**RESPONSE TO BRISBANE CITY COUNCIL INFORMATION REQUEST: S.13 OF THE
DEVELOPMENT ASSESSMENT RULES**

**DEVELOPMENT PERMIT FOR A MATERIAL CHANGE OF USE FOR SHOP (EXTENSION) AND
VETERINARY SERVICE OVER LAND AT 548 KESSLES ROAD, MACGREGOR (LOT 102 ON
SP249183)**

COUNCIL REFERENCE: A007067434

Figure 1 – Proposed Refuse Enclosure for Vet Clinic (MCA Architects, 2026)

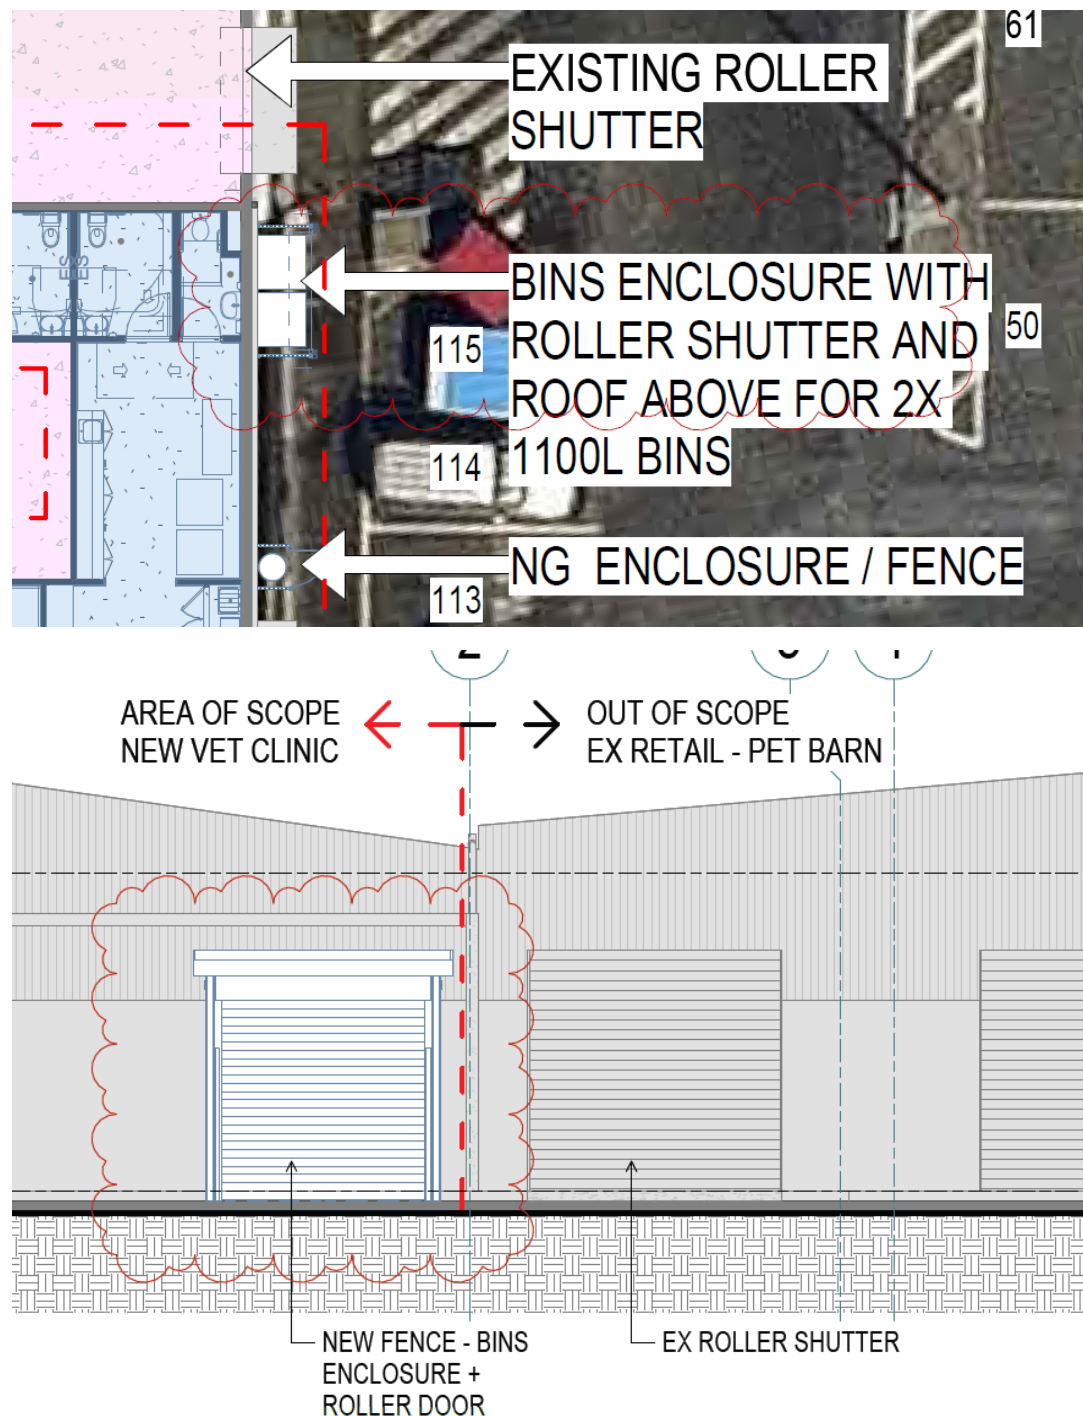
- a. Clearly demonstrate the location of the shops existing refuse storage area.*
- b. Denote the quantity, size of bins and service frequency of the shops refuse solution.*
- c. Demonstrate the Veterinary Services "Bin Store" has been roofed and wholly screened.*
- d. Annotate the area (m2) and internal dimensions of the "Bin Store".*

- (c) Bins associated with the proposed vet clinic are to be stored in a roofed and screened bin enclosure that is located outside the building and adjacent to the online loading / servicing bay (as illustrated in **Figure 1**). The bin enclosure has been designed to accommodate 1 x 1,100L 'general waste' and 1 x 1,000L 'commingle recycling'.

Figure 4 – Proposed pedestrian crossing (MCA Architects, 2026)

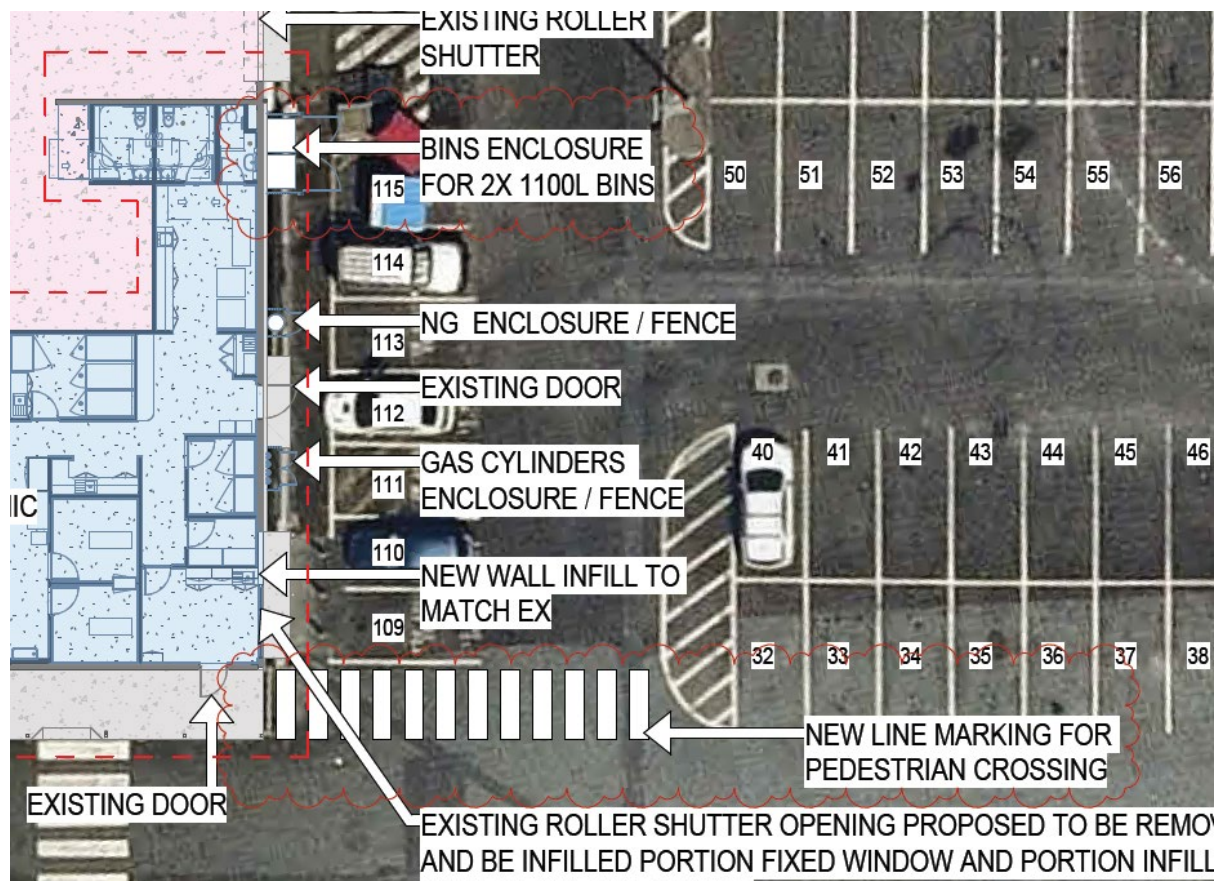
The architectural plans show storage areas for gas cylinders, NG and bins along the northern side of the building which appears to conflict with a pedestrian path.

- a. *Provide further clarification demonstrating safe pedestrian access is provided.*

The storage areas for the gas cylinders, NF and bins have been maintained along the northern side of the building, with this area not intended to be used for pedestrian movement due to the proximity of car parking spaces in this location.

These seven (7) car parking spaces will be line marked as 'staff only' (long-stay parking), with customers to utilise the spaces over the broader car parking area.

A new pedestrian crossing is proposed to provide safe access from the concrete footpath along the eastern side of the building (where the customer entrances are located) to the car parking area (as illustrated in **Figure 4**). Appropriate signage will be installed to direct the path of travel of pedestrians towards the new crossing.
